**Re: Duke Energy Carolinas, LLC's and Duke Energy Progress, LLC's
Supplemental Reply Comments
Docket No. E-100, Sub 165**

DOCKET NO. E-100, SUB 165

In the Matter of
2020 Biennial Integrated Resource Plans) DUKE ENERGY CAROLINAS, LLC'S
and Related 2020 REPS Compliance) AND DUKE ENERGY PROGRESS,
Plans) LLC'S SUPPLEMENTAL REPLY
) COMMENTS

Figure 1: Synapse Report Figure 5, First Corrected Version.

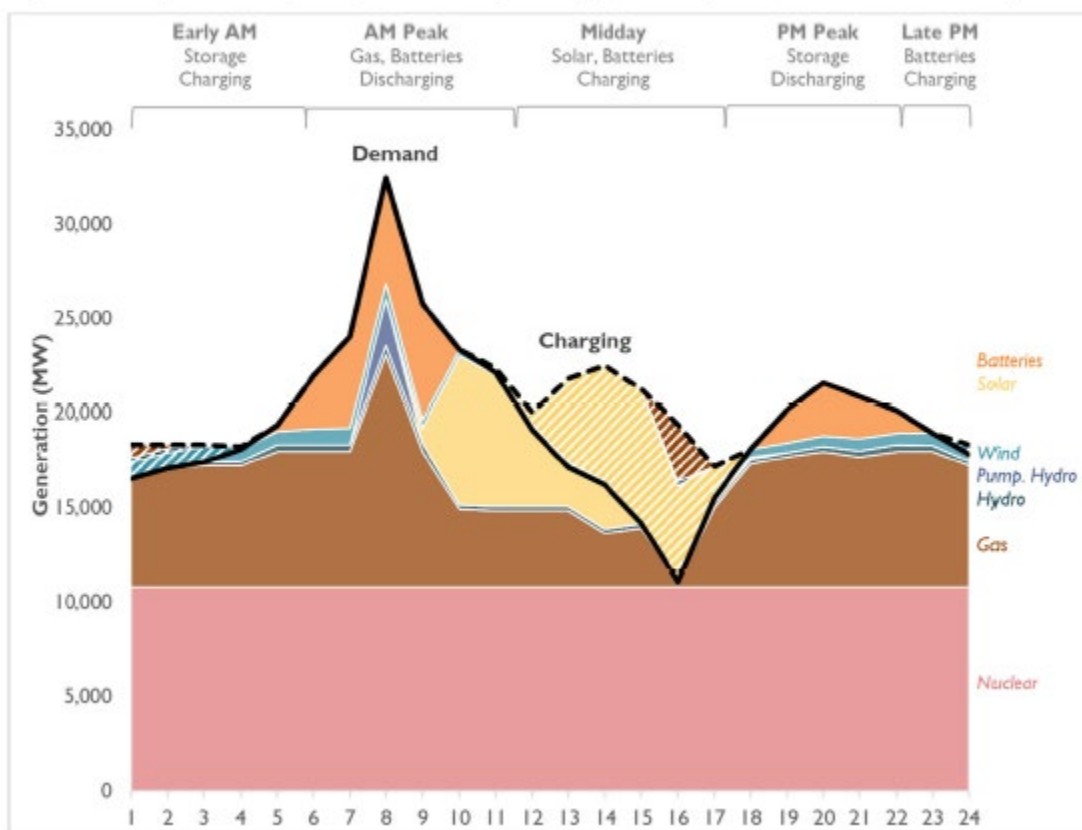
As explained in the Companies' initial Reply Comments, this load shape, with its steep needle peak and deep, mid-day valley, favors the selection and use of low cost, shorter duration capacity resources like battery storage and increases costs for traditional resources.²⁴ Figure 1 shows how the narrow peak allows for large amounts of battery storage to clip the peak by discharging during these hours of high demand, and then recharging the battery during the deep valley, when solar energy is generating during daylight hours. This artificially increases the value and promotes the selection of the battery storage resources in Synapse's Reasonable Assumptions portfolio, while at the same time discouraging solar additions in the Mimic Duke portfolio as the Companies' winter peaks do not align with the distorted load shape used for the selection of resources. Importantly, the Second Corrected Synapse Report relies upon the same inaccurate and unrealistic load shape in its capacity expansion and hourly production cost modeling to actually develop the two portfolios.²⁵

Figure 2: Synapse Report Figure 5, Second Corrected Version.

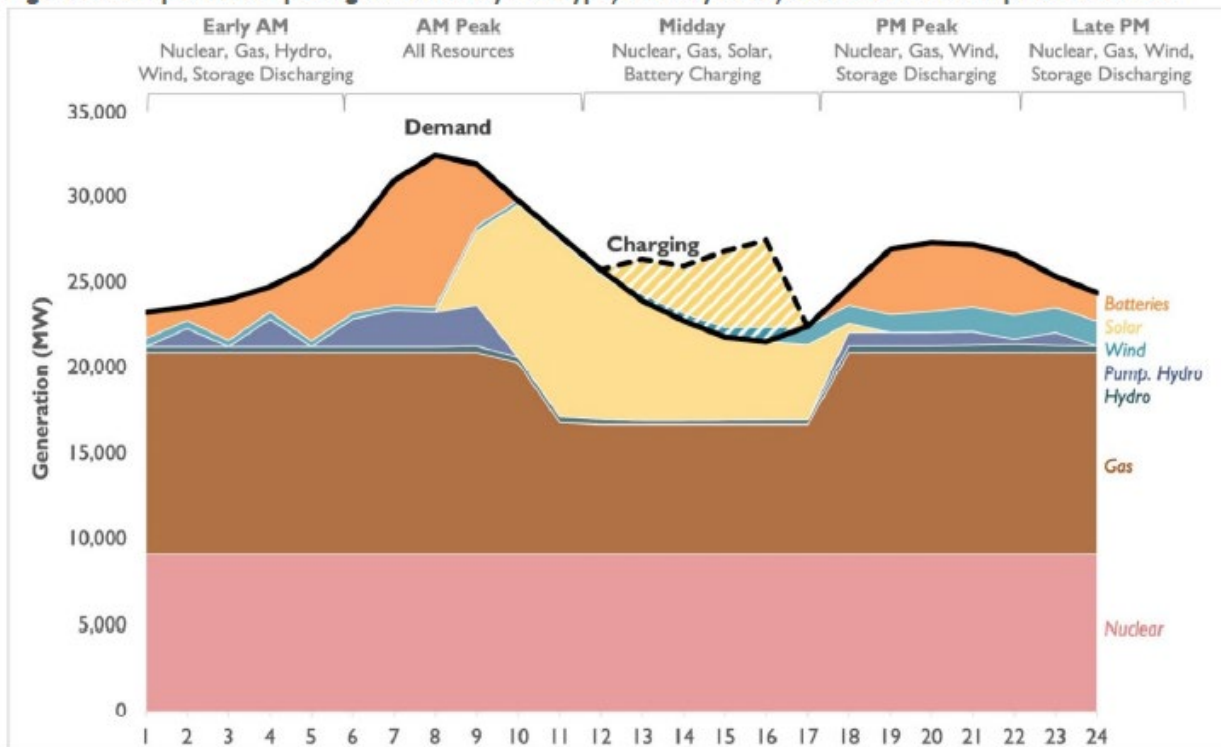
For the purpose of presenting updated Figures 4 and 5 in the Report, however, Synapse ran an additional production cost run with a more realistic peak winter load shape to create the graphs and to show that the generation of each portfolio can meet load with a more realistic real world load shape. Figure 2 is the updated Figure 5 from the Second Corrected Synapse Report, showing the change in load shape for these previously presented graphs.

While Synapse displays these graphs in its Second Corrected Report to show how even in peak winter events, the Reasonable Assumptions portfolio is just as reliable, the Companies disagree that Synapse’s limited analysis supports this conclusion.²⁶ First, the Reasonable Assumptions portfolio relies on an overly optimistic EE forecast to lower peaks and reduce energy needs around the clock at levels that are unachievable, as discussed in Section V below. Second, the load forecast used as a basis for the IRPs utilized weather normal load data meaning that the Reasonable Assumptions portfolio runs the risk of exhausting its available storage energy following the peak load day used for this graph. Figure 3 below uses the data consistent with Figure 5 from the Synapse Report, produced by Synapse in discovery, to show the battery storage energy availability under the

Figure 3: Storage Availability During Winter Peak Day in Synapse Report Figure 5 and Succeeding Days

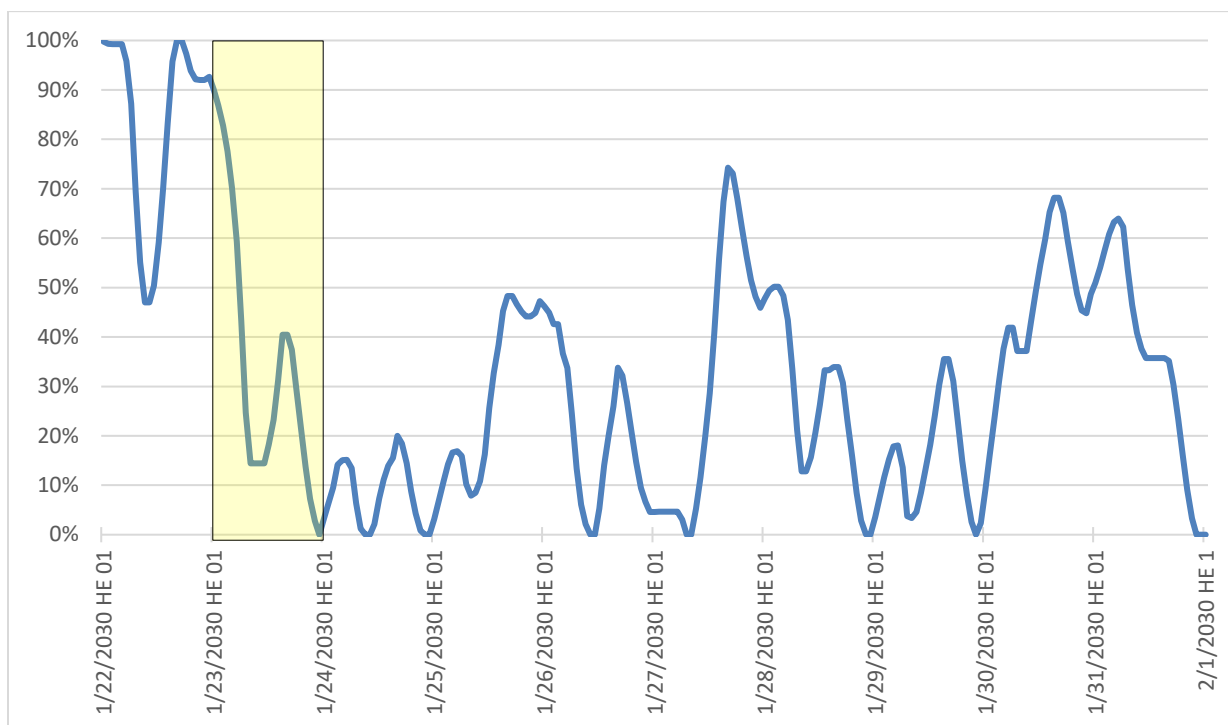
Reasonable Assumptions scenario for the final 10-day period in January 2030. The winter peak day, shown in Figure 5 from the Synapse report, is highlighted in yellow. The day preceding the winter peak day shows the system's storage capacity is at full capacity. Over the next two days, however, the system completely drains the battery. The days following the peak winter day show the limited amount of opportunity for the batteries to recharge before being called on again to discharge to zero.

Using this limited, one month simulation of weather normal load and depressed peak and energy needs from the unreasonable EE assumption creates increased reliability risk if the batteries do not have any available capacity charge. If a simulation with these more realistic load shapes is run over an entire study period, or with non-weather normal load forecasts, or if winter weather events resulting in sustained, elevated loads, then portfolios overly reliant on batteries like the Synapse Reasonable Assumptions portfolio

Figure 4: Original PVRR Calculations for Mimic Duke and Reasonable Assumption [Billions \$, 2021]

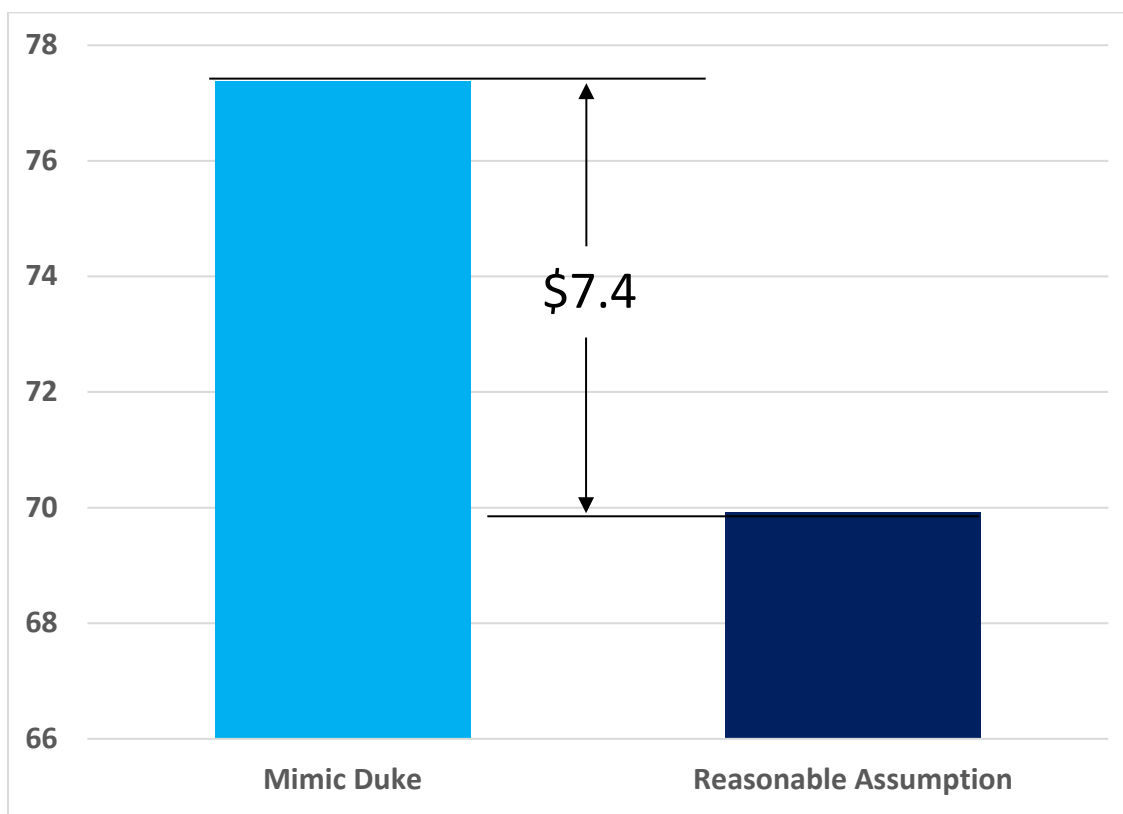
The original PVRRs calculated by Synapse shows a \$7.4 billion savings of the Reasonable Assumptions portfolio over the Mimic Duke portfolio. Figures 5 and 6 show the relative impact of each adjustment to address each of the issues mentioned above for each of the portfolios. Excluding the explicit cost of carbon is colored green with a downward arrow showing the reduction in the cost of both plans. The following three categories, Technology Cost Adjustment, Renewables and Storage Levelization Correction, and EE Cost Correction, are colored red and show increases to the Reasonable Assumption portfolio to correct these errant cost assumptions, while these adjustments have no impact

Figure 5: PVRR Adjustments to Mimic Duke [Billions \$, 2021]

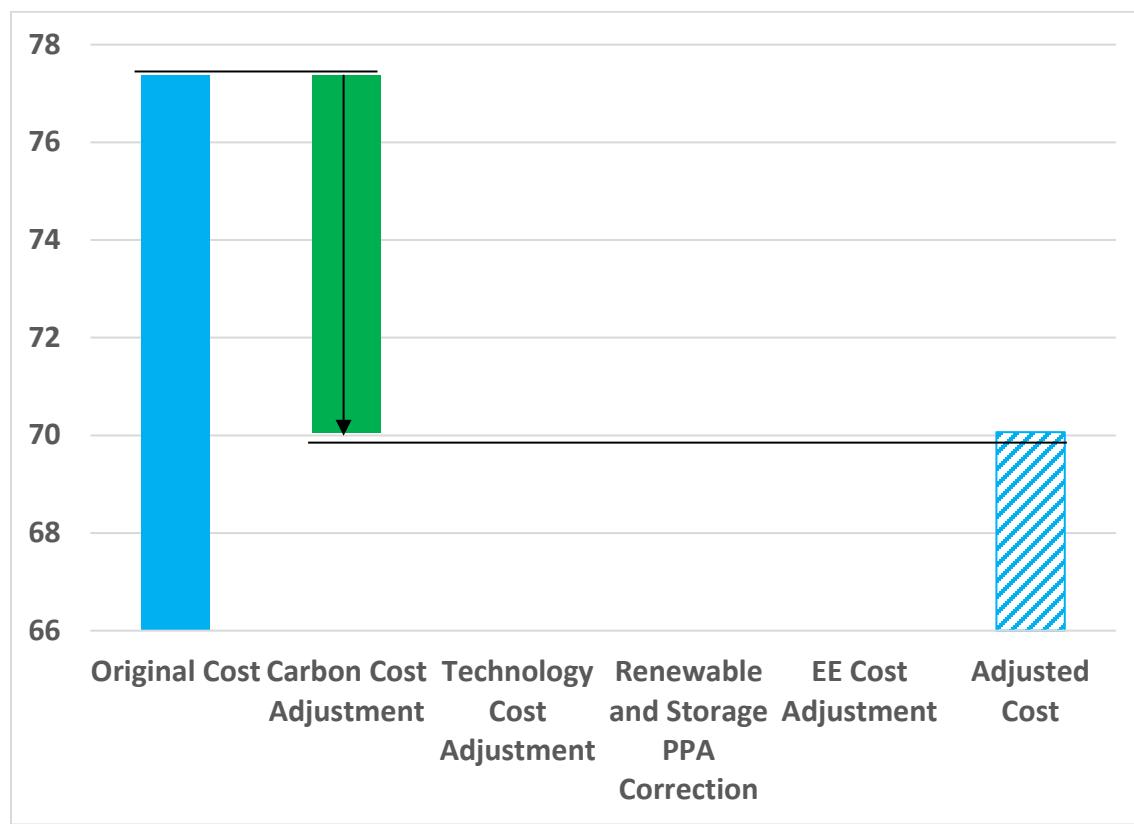
to the Mimic Duke portfolio. After the sum of these adjustments, the final cross-hashed bar in each of the graphs shows the total adjusted cost of the portfolio.

Figure 7: Adjusted PVRR Calculations for Mimic Duke and Reasonable Assumption [Billions \$, 2021]

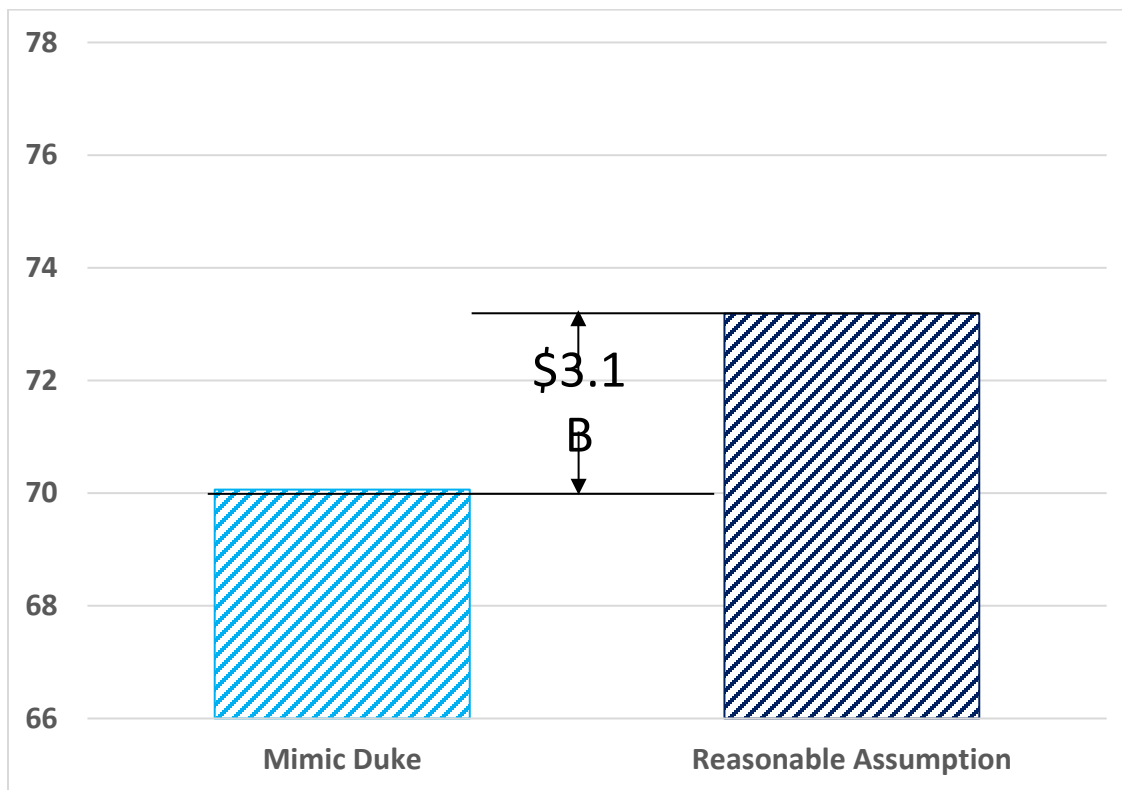
The final figure below, Figure 7, compares the adjusted Mimic Duke PVRR to the adjusted Reasonable Assumptions PVRR.

After these corrections and adjustments, the Mimic Duke portfolio becomes \$3.1 billion less than the Reasonable Assumptions portfolio, even with its over-reliance on solar and storage and restrictions on new natural gas generation.
